**CONTRACT DOCUMENTS
BOONE COUNTY, MISSOURI
BOONE COUNTY FAIRGROUND PAVEMENT MAINTENANCE # 9755
BID NO: 26-17APR03**

ADDENDUM #1

County of Boone
Fairgrounds Pavement Maintenance
 Pavement Patch

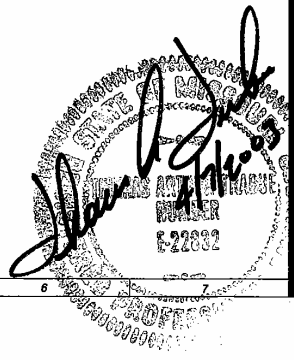
1. Specification Section 02951: A detail is provided to depict the anticipated work required to repair a pothole / construct a small pavement patch.

* For Small Areas, Type 1 Aggregate may be used Full Depth
 Thickness May be Decreased if Solid Material is an Existing Granular Base

** For Gravel or Chip/Seal Surfaces Substitute Type 1 Aggregate
